PLANNING AND ZONING COMMISSION ITEM:  
PC-21-13

**Master Development Plan (MDP)**  
Honey Creek

## **REVIEW MEMORANDUM**

**SUBJECT:** Honey Creek MDP Review  
PC-21-13

## HONEY CREEK COMAL COUNTY, TEXAS SLOPE MAP AND RIPARIAN BUFFER EXHIBIT

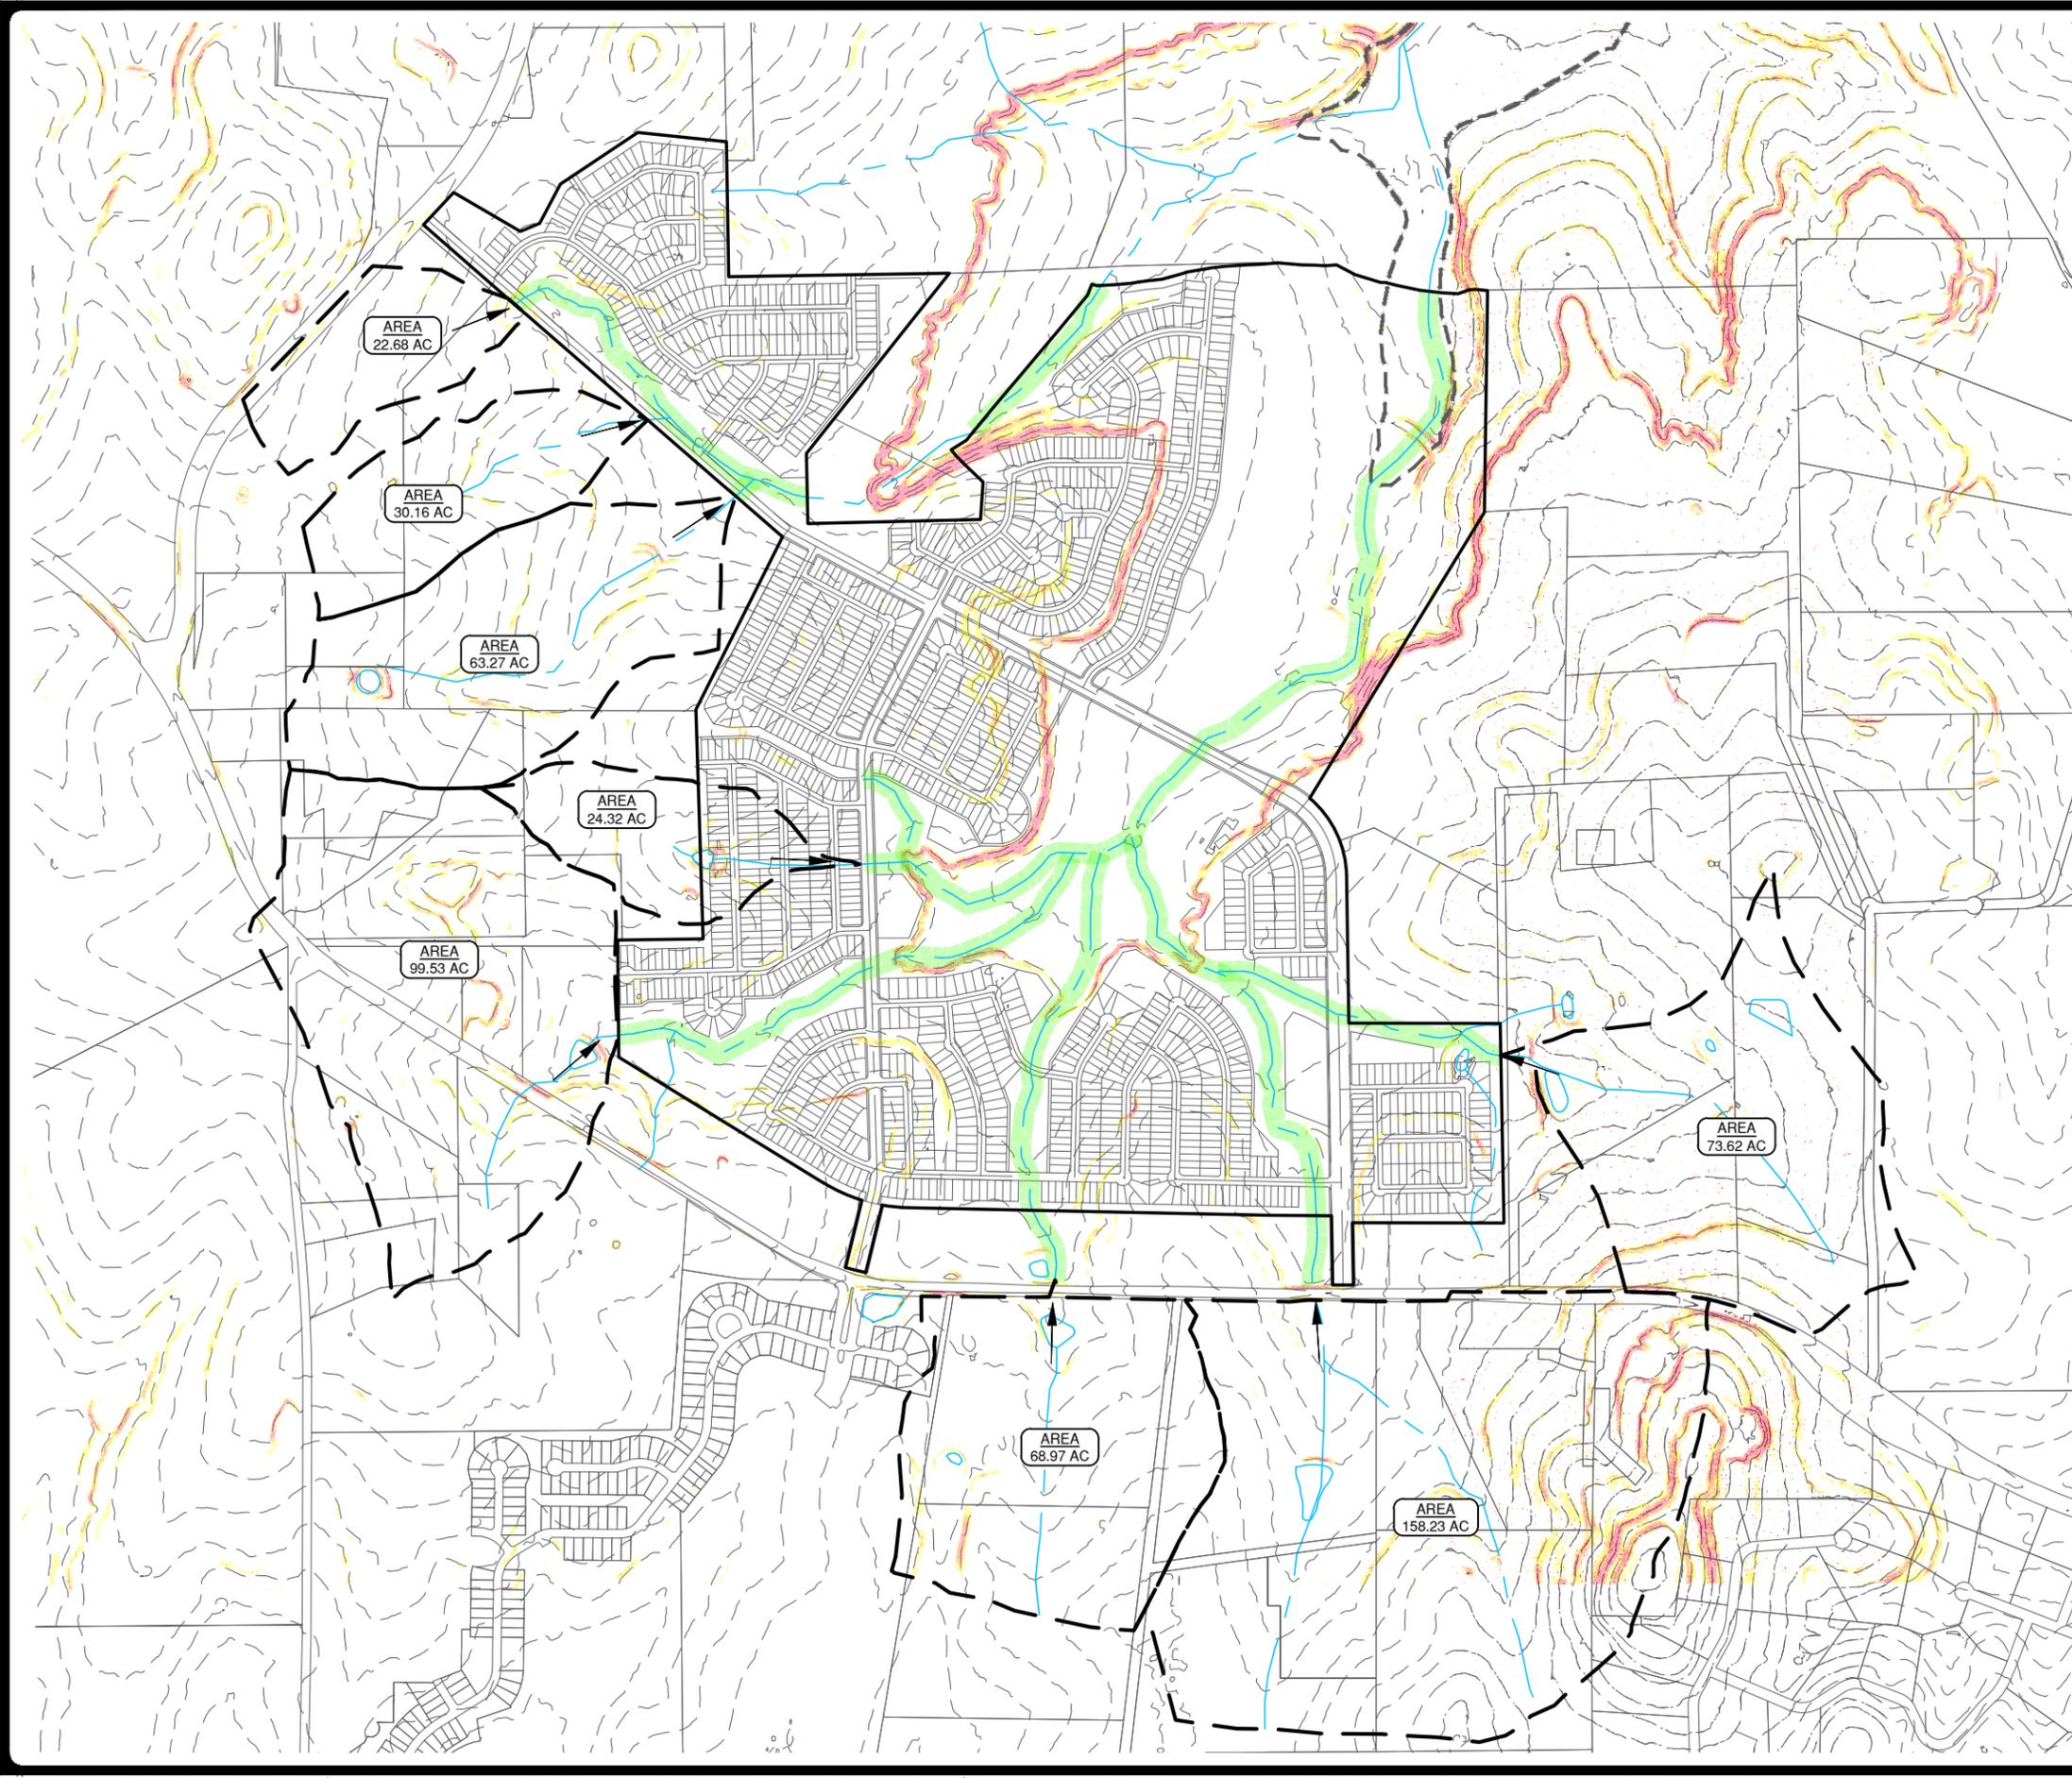
1. Are the dashed areas drainage areas? Add them to the legend. – [Comment resolved](#)
  4. Model – [Not provided...could not verify](#)
    1. The model has N1, N2, S, and Junction W all going to the outfall. The DA map appears to show N1 flowing to N2, W1 and W2 flowing to W3, and W3 flowing to N2 before the outfall. Please ensure the subbasins are modeled properly.
